STATE OF CALIFORNIA
 CALIFORNIA NATURAL RESOURCES AGENCY
 DEPARTMENT OF WATER RESOURCES
 DIVISION OF SAFETY OF DAMS

INSPECTION OF DAM AND RESERVOIR IN CERTIFIED STATUS

Name of Dam Phoenix Lake Dam No. 33-3 County Marin
 Type of Dam ERTH Type of Spillway Concrete weir and chute
 Water is 0.1 feet above the spillway crest and 15.1 feet below the dam crest.
 Weather Conditions Clear and mild
 Contacts Made Lucy Croy and Conner Pollard during the inspection
 Reason for Inspection Periodic Evaluation

Inspected by J. Lowe
 Date of Inspection 14 February 2018
 Date of Report 16 February 2018

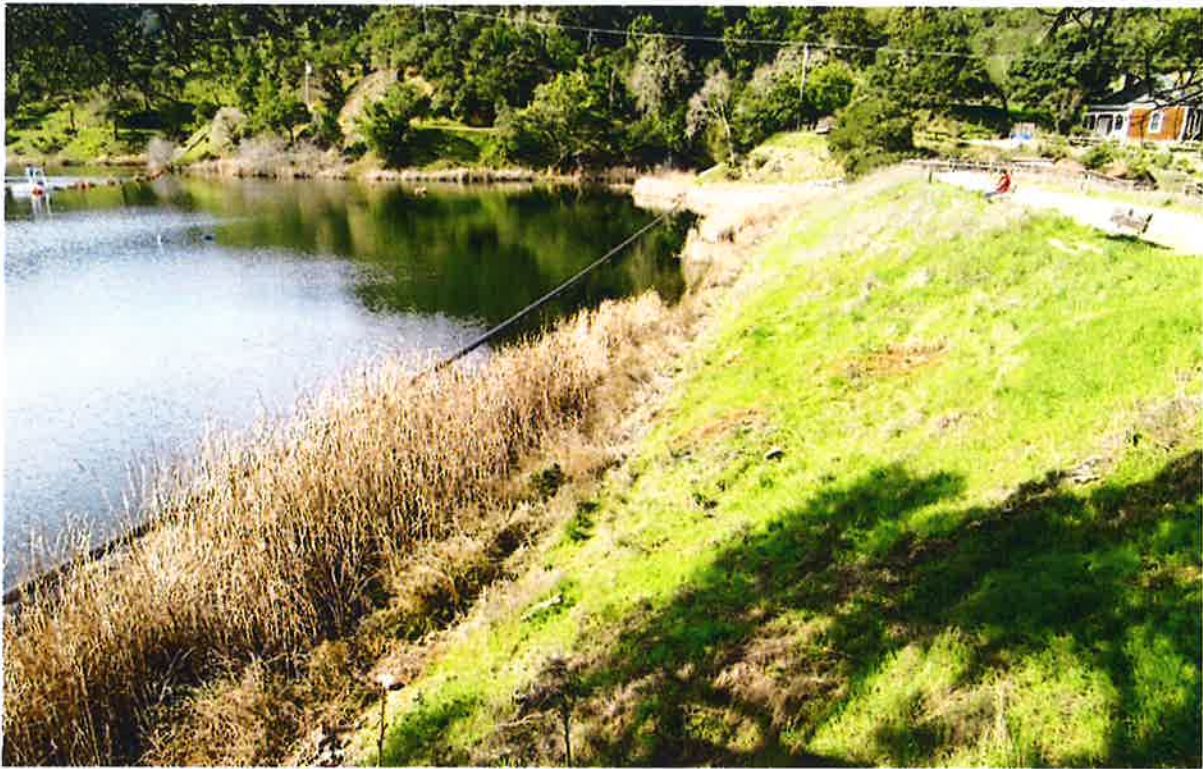
Spillway crack data covers the period between December 2005 and June 2017. Crack monitors indicate horizontal displacements are cyclic, though following recent recalibration of the extensometers and data logger in late 2015, reported displacements have increased many fold and are now in the 25 mm to 35 mm range. The reported displacements are inconsistent with observations in the field, and I asked Ms. Croy to continue to evaluate the performance of both the spillway and the spillway crack monitoring instrumentation.

The owner's conclusions from their June 2017 submittal were that, "The Phoenix Lake piezometer readings are consistent with historic readings. ... The Phoenix Lake Dam spillway crack monitors indicate horizontal and vertical displacements. Crack meters and data loggers were removed in October 2015 and sent to the manufacture for calibration. Calibrated equipment and a new vertical crack meter were installed in early February 2016. ... Data since recalibration does not align with previous crack meter data and is currently under review of accuracy and calibration to determine if the spillway crack will need repairs. ... Phoenix Lake dam is trending toward stabilization: settlement of -0.35 ft (maximum) and alignment of -0.28 ft. (downstream direction; maximum)". Based on the data submitted I agree with the owner's conclusions. ***The dam appears to be performing satisfactorily, and no additional instrumentation is believed necessary at this time, but careful and consistent monitoring of the spillway crack is imperative, and any indication of potentially adverse displacements must be reported to DSOD immediately.***
